Northeast Water Purification Plant (NEWPP)  
Improvements Package No. 2 – High Service Pump Station  
and Miscellaneous Piping Improvements  
WBS No. S-000066-012A-4

NOTICE OF  
ADDENDUM NO. 1

Date of Addendum: 11/10/15

ADDENDUM NO. 1

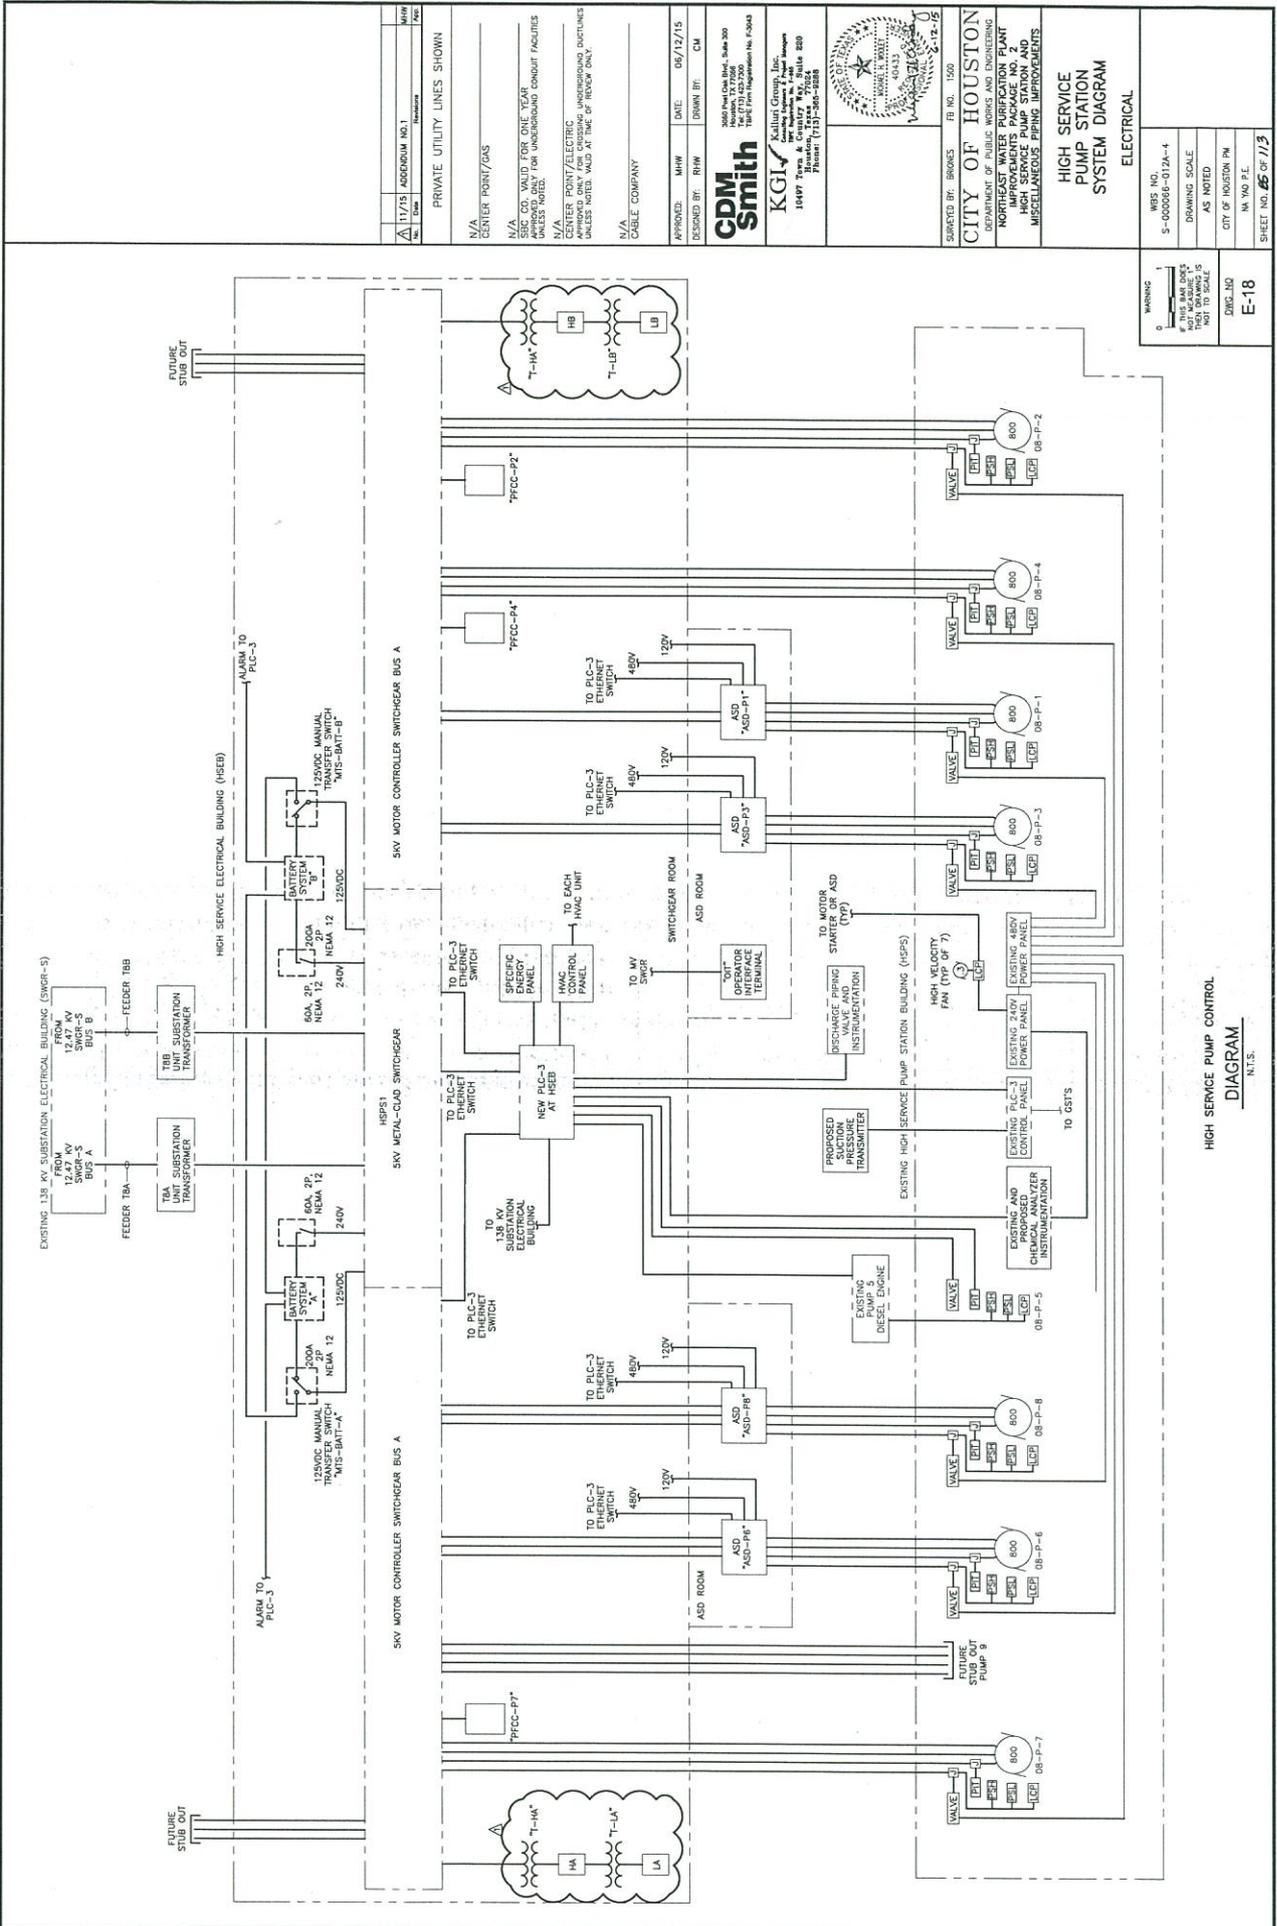
3. Question: Per Sheet 89, existing Panel 08-STBY-LP01 shows to be 480V. Please clarify correct voltage.

Answer: The existing HSPS low voltage Panel 08-STBY-LP01 is 120/208 Volt. Sheet 89 is revised.
